Technical Bulletin

34 07 05 Aug. 22, 2007 2015981

Transmission, Manual 6 Speed (MQ350), Knocking Noise under Load

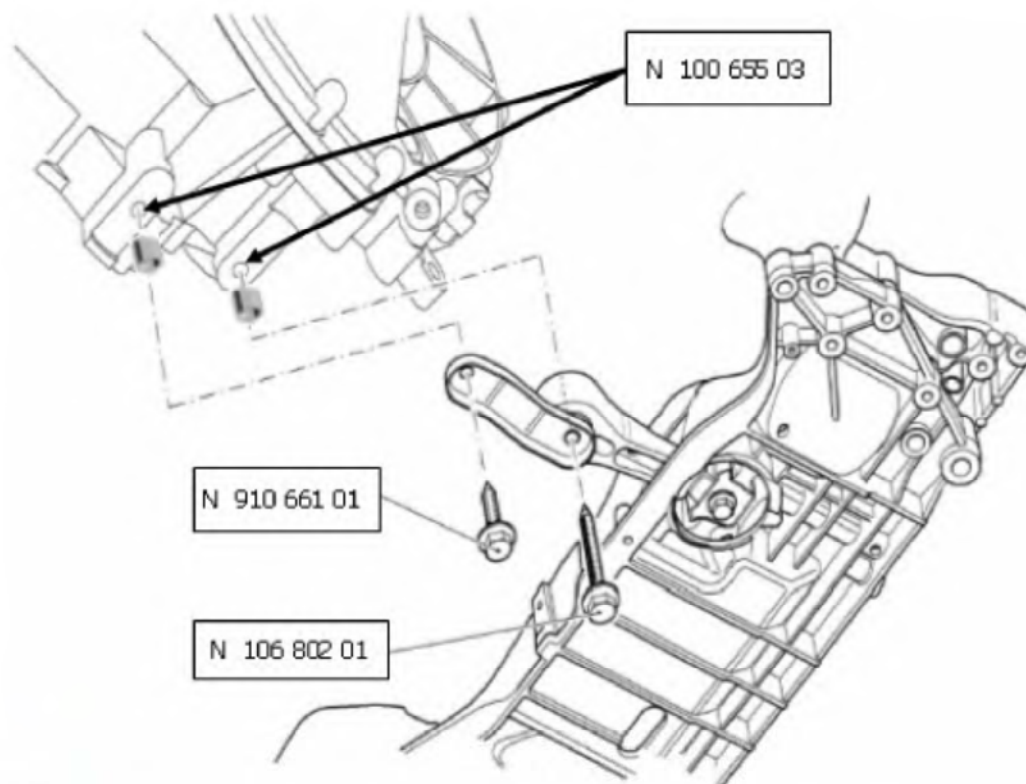
Knocking noises at load change from pendulum support.

Connection between pendulum support and gearbox may be loose.

Engine vibrations affect the connection and may loosen the bolts.

1. Check pendulum support bolts.
2. If bolts are found to be loose:
 - a. Remove bolts.
 - b. Discard original bolts.
 - c. Install HeliCoil® thread elements (N10065503) on both threads in the gearbox housing.
 - d. Install pendulum support and secure with new bolts listed below:
 - M 10x35 (N91066101)
 - M 10x75 (N10680201)

Contrary to the repair manual use the following torque for installing the pendulum support:
Tighten bolts to 50 Nm (37 ft. lbs.), plus 90°.

Because of anti-corrosion protection, the above HeliCoil® elements MUST be used.
If elements without surface coating are used, the thread can be deteriorated by corrosion.
